Salem Generating Station Units 1 and 2
Renewed Facility Operating License Nos. DPR-70 and DPR-75
NRC Docket Nos. 50-272 and 50-311

Subject: Response to Request for Additional Information for Proposed Alternative for Examination of ASME Section XI, Examination Category B-B, Item Number B2.11 and B2.12

Attachment 1: Response To Requests for Additional Information Salem Generating Station
Units Nos. 1 and 2 Regarding Alternative for Examination of ASME Section XI,
Category B-B, Item Number B2.11 And B2.12, EPID L-2020-LRR-0103

**Figure RAI-1-1: Applied K vs. Fracture Toughness as a Function of Temperature
for Case ID PRSHC-BW-2C**

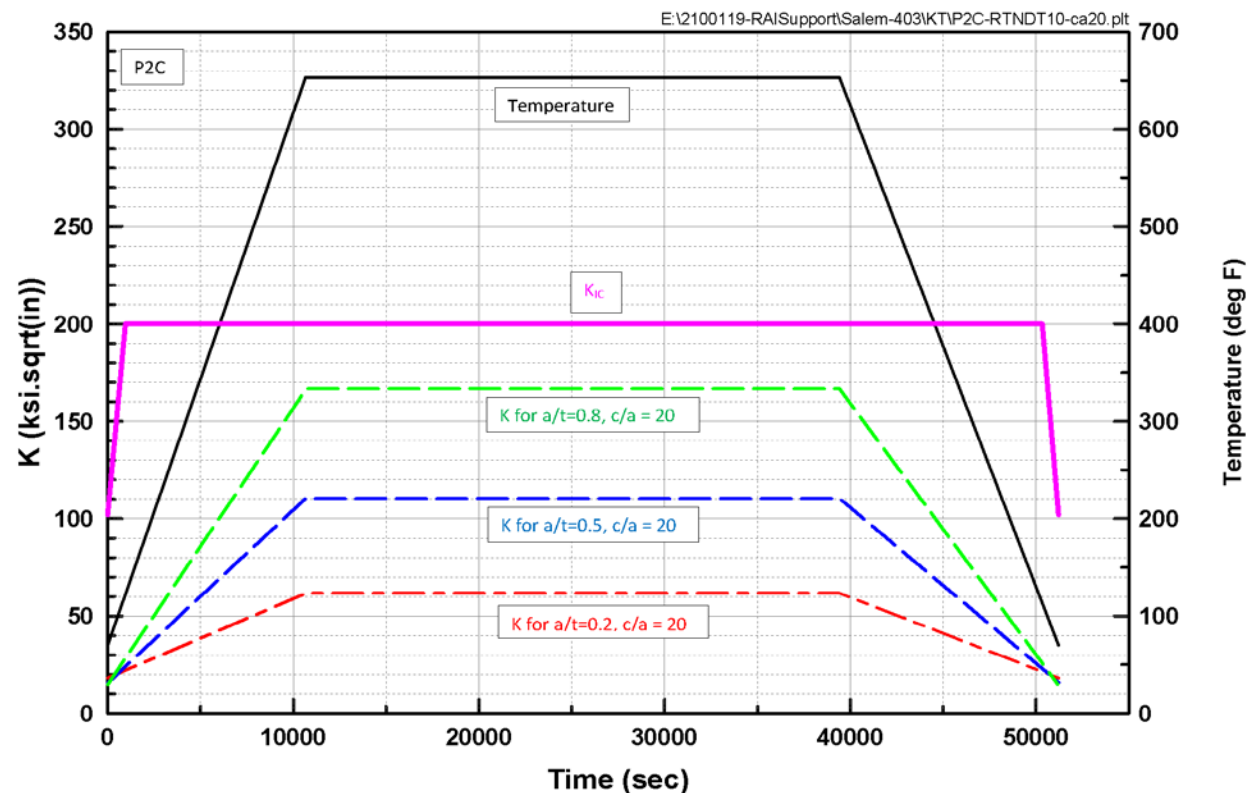
Table 5-6 of EPRI report 3002015905 shows that the temperature of the pressurizer (TPZR in the table) applicable to the Examination Item Numbers B2.11 and B2.12 PZR SHWs of Salem Units 1 and 2 requested in the submittal ranges from 70°F to 653°F for the Heatup/Cooldown transient. Section 8.2.2.6 of EPRI report 3002015905 explains that a fracture toughness (KIC) set at the upper shelf value of the ASME Code KIC curve, 200 ksi√in, may be used. In the audit summary report for PROMISE Version 1.0 (ADAMS Accession No. ML20258A002, Item No. 2.e.iii), the NRC staff observed that for the steam generator feedwater nozzle, KIC could be as low as 130 ksi√in during the Heatup/Cooldown transient and that this lower value of KIC is addressed by the sensitivity study on fracture toughness in Tables 8-13 and 8-14 of non-proprietary EPRI Report No. 3002014590, "Technical Bases for Inspection Requirements for PWR Steam Generator Feedwater and Main Steam Nozzle-to-Shell Welds and Nozzle Inside Radius Sections", April 2019 (ADAMS Accession No. ML19347B107). The NRC staff noted that the lowest KIC value, 80 ksi√in, used in the sensitivity study on fracture toughness in EPRI report 3002015905 is the same as the lowest KIC value used in the sensitivity study on fracture toughness in EPRI report 3002014590. However, the NRC staff noted that the pressure for the B2.11 and B2.12 PZR SHWs of Salem Units 1 and 2 is more than twice the pressure analyzed for the SG feedwater nozzle in EPRI report 3002014590 since these welds are on the primary

side of the reactor coolant system. Since the pressure is more than twice than what was previously analyzed for the SG feedwater nozzle, the staff cannot determine how much lower than 200 ksi in the KIC value could be during the ramp periods in the beginning and ending of Heatup/Cooldown transient for the subject PZR SHWs.

Given the NRC staff's observations discussed above for the B2.11 and B2.12 PZR SHWs of Salem Units 1 and 2, explain how the sensitivity study on fracture toughness in EPRI report 3002015905 addresses the low KIC value that could exist during the ramp periods in the beginning and ending of the Heatup/Cooldown transient for the subject PZR SHWs.

From the deterministic fracture mechanics (DFM) results in Table 8-4 of EPRI Report 3002015905, the critical Case ID for Item Nos. B2.11 and B2.12 is PRSHC-BW-2C (both with and without surge nozzle piping moments). This Case ID also shows the most sensitivity to fracture toughness in the probabilistic fracture mechanics (PFM) evaluation as presented in Tables 8-15, 8-16 and 8-32 of EPRI Report 3002015905. Therefore, Case ID PRSHC-BW-2C was selected for an additional evaluation to respond to this RAI request.

The stress intensity factor (K) and temperature histories at the inside surface for Case ID PRSHC-BW-2C for the Heatup/Cooldown transient (including RCS pressure) are provided in Figure RAI-1-1 for three flaw depths that span the range of depths covered in the evaluation ($a/t = 0.2, 0.5$ and 0.8). Based on a review of the supporting calculations, the maximum aspect ratio (crack half-length over depth, or c/a) from the DFM evaluation performed in Section 8.2 of EPRI Report 3002015905 for this Case ID ranged from approximately 1.7 to 3.6. A conservative (longer flaw) aspect ratio, c/a , of 20 was selected for use in this evaluation.

The stress intensity factor time histories were calculated for the three flaw depths for the Heatup/Cooldown transient, and the fracture toughness history for the transient was calculated using the equation for K_{IC} in Paragraph A-4200 of Nonmandatory Appendix A of ASME Code, Section XI. A maximum plant-specific RT_{NDT} of 10°F was used for the Salem Units 1 and 2 pressurizers based on a review of all plant-specific pressurizer certified material test reports (CMTRs) and fabrication inspection reports. As shown in Figure RAI-1-1, the calculated applied Salem-specific stress intensity factors are bounded with margin by the corresponding K_{IC} calculated as a function of temperature throughout the transient, for all three flaw depths.

**Figure RAI-3-1: Time History Stresses (Pressure Plus Thermal)
at the Inside Surface for Path P2 for the Heatup/Cooldown Transient**

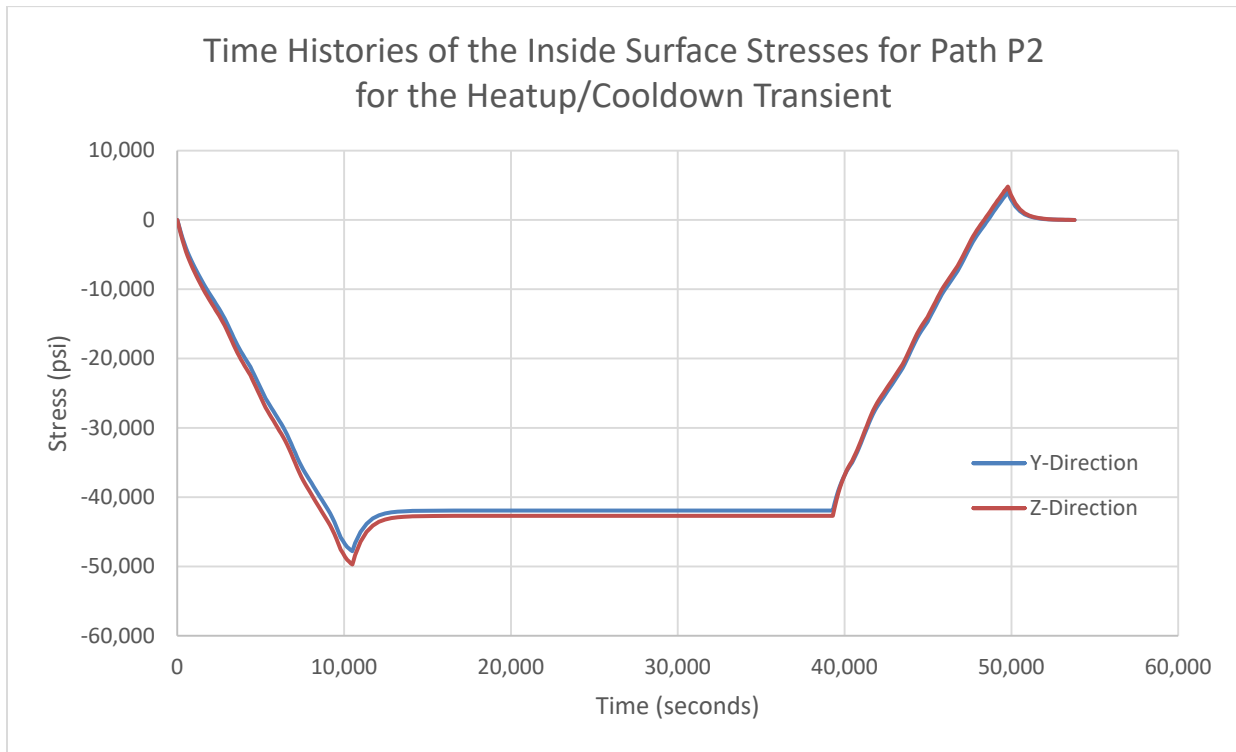
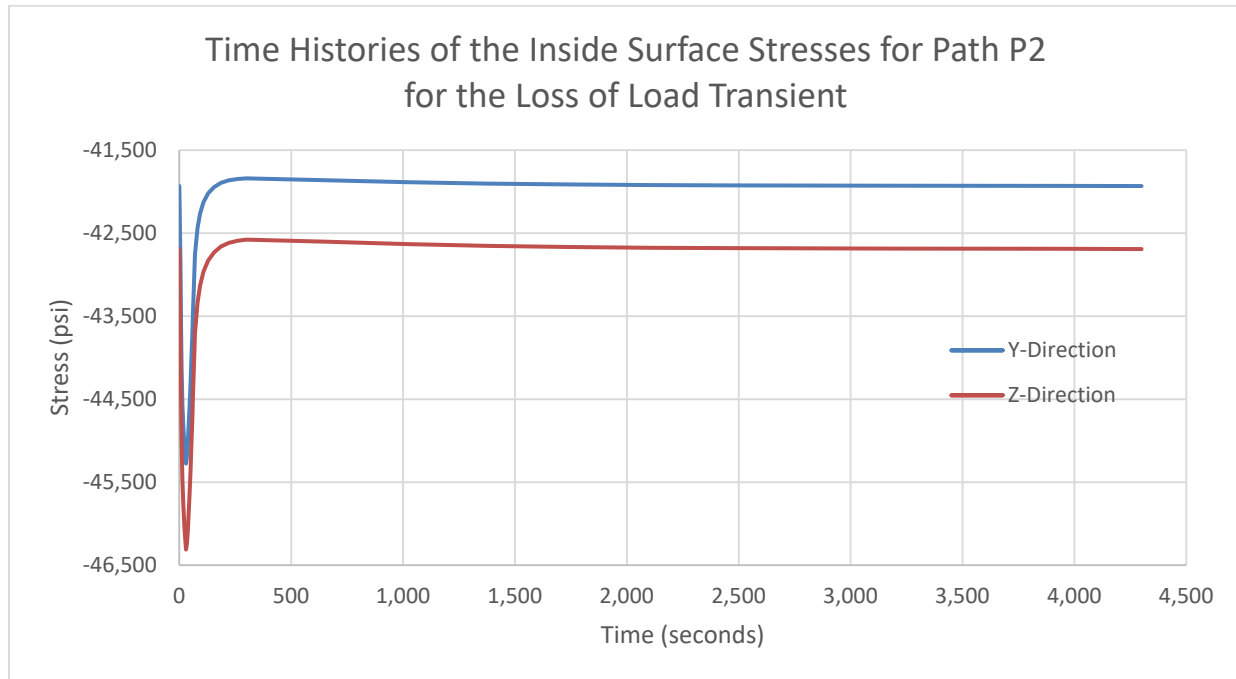
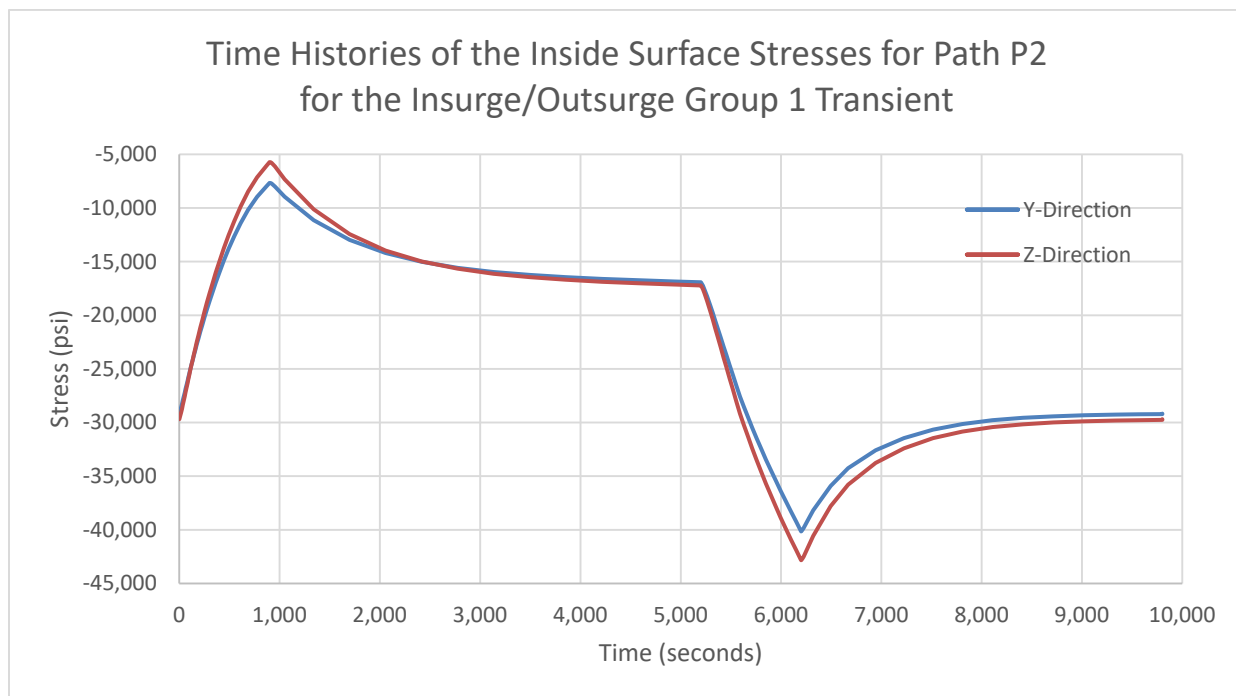
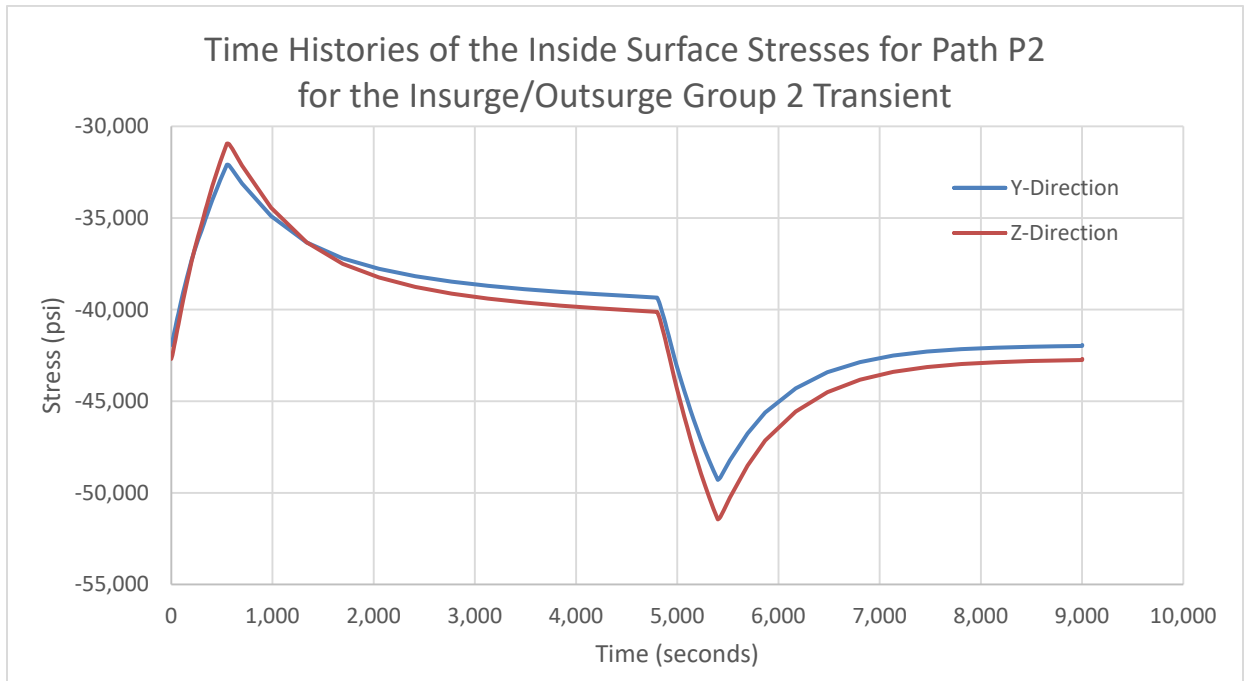
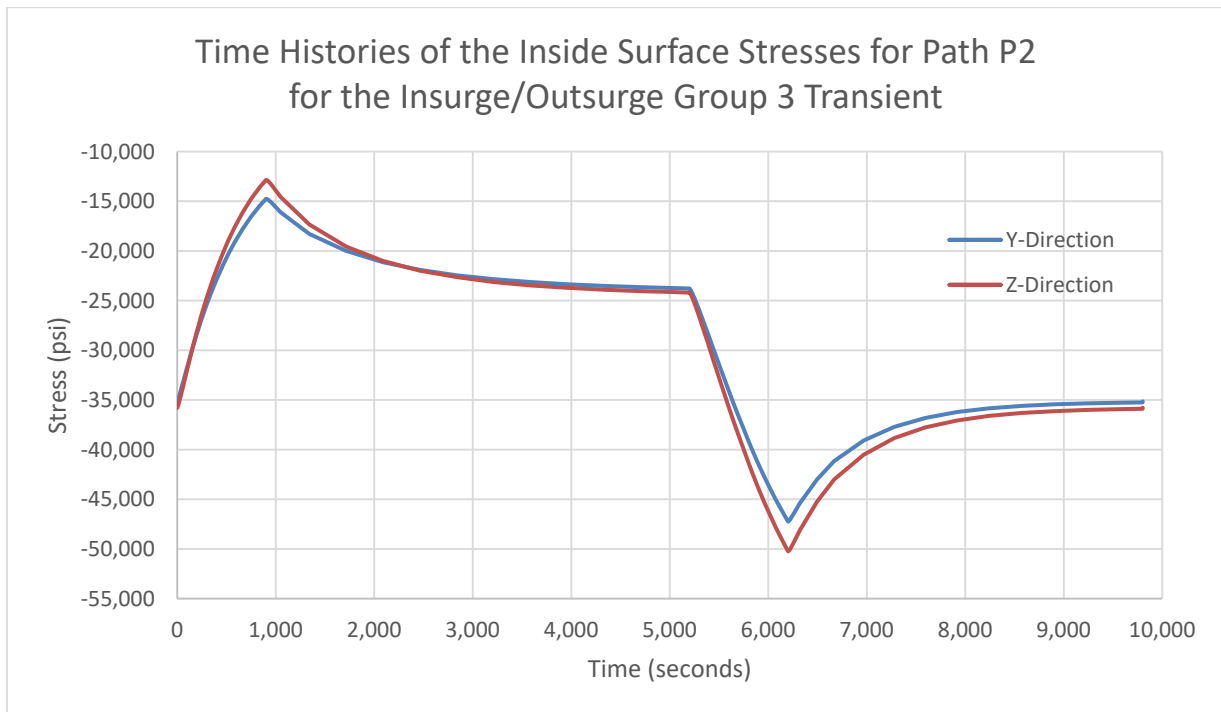
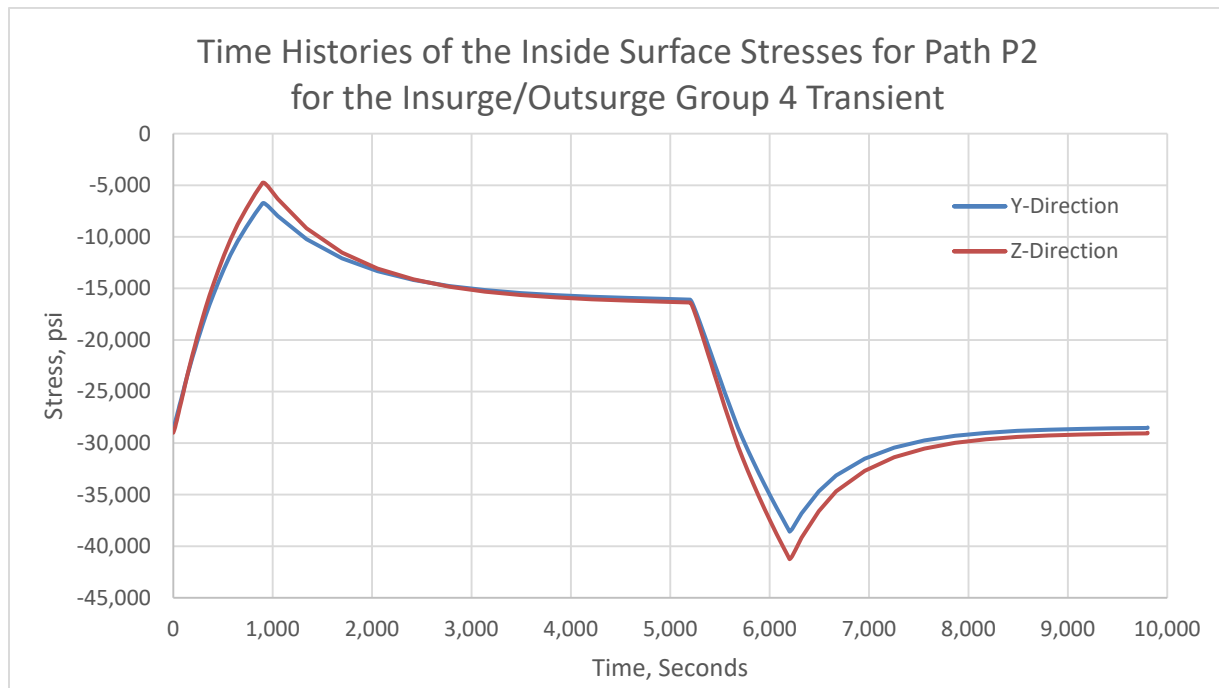
The through-wall stress distribution plots for the thermal transients in Figures 7-10 and 7-11, 7-22 through 7-25 of EPRI report 3002015905 for the subject PZR welds show compressive stresses at the inner surface. However, tensile stresses at the inside surface are typically expected for transients that have temperature drops, such as the Insurge/Outsurge transients listed in Table 5-9 of EPRI report 3002015905 and the Loss of Load transient in Table 5-6 of EPRI report 3002015905.

To assure that the thermal stress behavior in the subject PZR welds analyzed is reasonable, explain if the thermal stresses on the inside surface shown in the referenced figures of EPRI report 002015905 become tensile at times other than those shown in the figures.

The general trends are similar in all the through-wall stress profiles in Figures 7-10, 7-11, 7-22, 7-23, 7-24 and 7-25 of EPRI Report 3002015905. Therefore, the limiting stress path was selected for illustration in this response. Based on the results of the deterministic fracture mechanics (DFM) evaluation summarized in Section 8.2.3 and Table 8-4 of EPRI Report 3002015905, the limiting stress path is Path P2 for the pressurizer lower head-to-vessel weld. Path P2 is shown in Figure 7-9 of EPRI Report 3002015905. Inside surface stress histories were generated for limiting stress Path P2 for all six of the evaluated transients listed in Tables 5-6 and 5-9 of EPRI Report 3002015905 (Heatup/Cooldown, Loss of Load, and Insurge/Outsurge Groups 1 through 4 transients). These six plots are shown in Figures RAI-3-1 through RAI-3-6. The stress histories in these figures can be compared to the stress profiles shown for Path P2 in Figure 7-11 of EPRI Report 3002015905.

For the Heatup/Cooldown transient stress histories shown in Figure RAI-3-1, the inside surface stress is zero at the start of the transient because there is no differential thermal expansion between the stainless steel cladding and the low alloy steel base material for the assumed, stress-free temperature of 70°F. Then, a significant compressive stress develops during the heatup because of the differential thermal expansion between the cladding and the base material as the temperature increases. The compressive stress reaches a maximum steady state value after 10,000 seconds when the heatup is complete. The stress then reverses during the cooldown that begins just before 40,000 seconds and becomes tensile at the end of the cooldown near the end of the transient (at 50,000 seconds).

All other transients (the Loss of Load and the four Insurge/Outsurge Groups) start with the pressurizer hot and therefore, the inside surface at the start of these transients is in significant compression due to the differential thermal expansion between the stainless steel cladding and the low alloy steel base material based on the stress-free temperature of 70°F. As shown in Figures RAI-3-2 through RAI-3-6, the stresses on the inside surface during these transients become less compressive because of the cooldowns that occur in each of the transients, but the temperature drops are not high enough during the transients for the inside surface stresses to become tensile.

Therefore, the thermal stress behavior in the analyzed pressurizer welds are reasonable in that they follow expected behaviors based on the inputs used in the evaluation.

Figure RAI-4-1: Initial Flaw Size Distributions

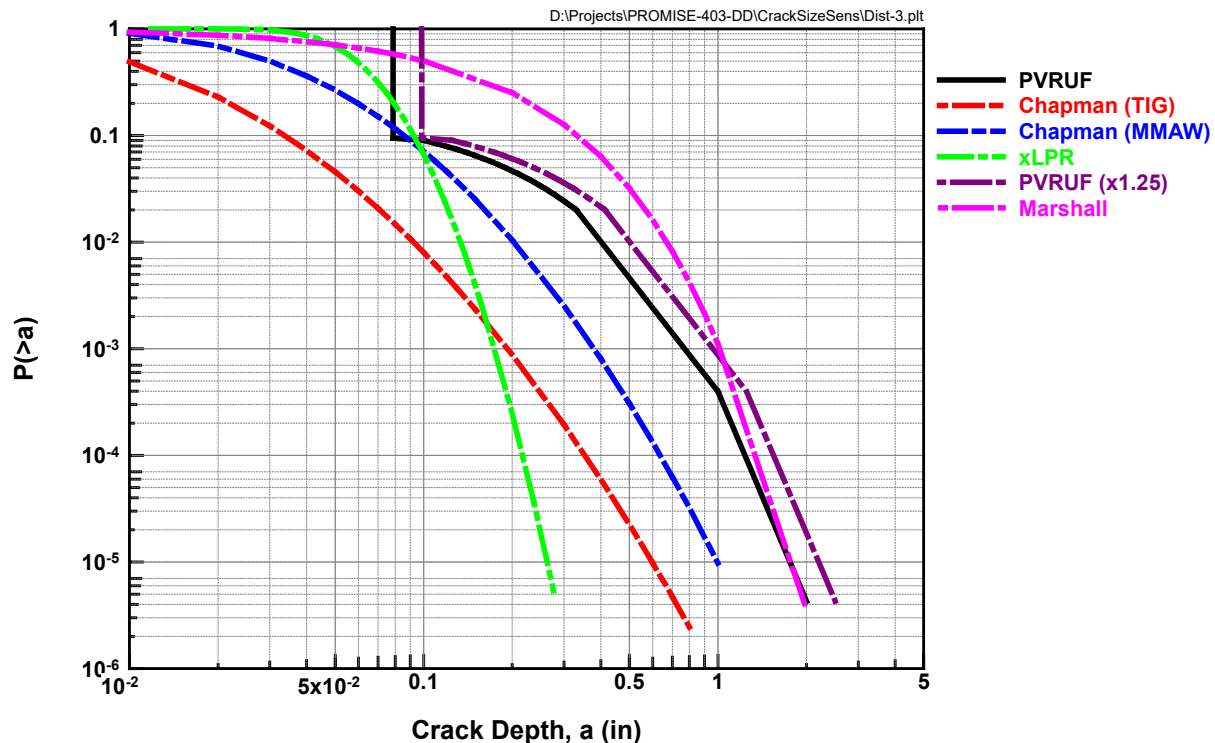
In Section 8.3.2.2 of EPRI report 3002015905, EPRI stated that the flaw distribution derived from flaw data from the Pressure Vessel Research User's Facility (PVRUF) vessel was applied to the PZR vessel in the analyses. NUREG-6471 "Characterization of Flaws in U.S. Reactor Pressure Vessels," (ADAMS Accession No. ML112510316, Reference 89 of EPRI report 3002015905) states that the PVRUF vessel is from an unused pressurized water reactor (PWR) vessel and that the PVRUF data are from fabrication flaws in the PVRUF vessel weldment. The nominal thickness of PWR vessels is 8 inches. Figure 4-4 of EPRI report 3002015905 shows the PZR vessel lower head model used in the analyses referenced for the Salem Units 1 and 2 SHWs in the PZR lower head; the figure shows that the PZR vessel cylindrical shell (vertical portion) is relatively thick, but the PZR lower head is only 2.55 inches thick. The staff noted that the PVRUF flaw data may not be appropriate for vessels much thinner than 8 inches since welding thinner vessels is different from welding thick vessels. Furthermore, Table A-1 in Attachment 1 to the submittal states that the upper and lower head of the Salem Units 1 and 2 PZR vessels are made of SA-216 Grade WCC, which is different from SA-533 and SA-508 Class 2 materials typically used for reactor pressure vessels. Section 8.3.2.2 of EPRI report

3002015905 included only a general discussion of the applicability of PVRUF to a PZR vessel, stating that "even though the PVRUF data were based on a reactor pressure vessel, they can be applied to a pressurizer vessel because both are large-diameter vessels fabricated from similar plate and forging process and from the same materials (SA-533 and SA-508 Class 2)." This discussion does not provide the staff sufficient information to determine that the PVRUF flaw data is appropriate for the Salem Units 1 and 2 PZR vessel lower SHWs, given that the modeled PZR lower heads are much thinner than reactor pressure vessels, and given the difference in materials of the Salem Units 1 and 2 PZR vessel lower heads from the materials of reactor pressure vessels.

Justify that the flaw distribution based on the PVRUF flaw data from a reactor pressure vessel is appropriate for the Salem Units 1 and 2 PZR vessel lower SHWs.

Five of the above initial flaw size distributions are plotted in Figure RAI-4-1, where the probability of finding a flaw greater in size than depth, a , or $P(>a)$, is plotted as a function of the flaw depth, a . Flaw distribution #6 (the "Theoretical" flaw distribution) would plot as a vertical line in this figure. For example, for the pressurizer lower head, the vertical line would occur at a crack depth, a , of 0.64 inches for all $P(>a)$ values (based on 25% of the minimum pressurizer lower head thickness of 2.55 inches shown in Table 4-4 of EPRI Report 3002015905).

It is noted that vessel flaw distributions (PVRUF or the shifted PVRUF) are considered to be most appropriate for application to the pressurizer because the pressurizer is a vessel with similar geometry, material and fabrication practices as those used to fabricate RPVs. On the other hand, the xLPR flaw distribution is applicable to dissimilar metal welds, which are not present in the subject pressurizer welds. Nevertheless, useful insights can be gained by comparing the probabilistic fracture mechanics (PFM) results from all six of the above flaw distributions to estimate the sensitivity in the PFM results from differences in the geometry, material, and fabrication practices that were assumed in each flaw distribution model.
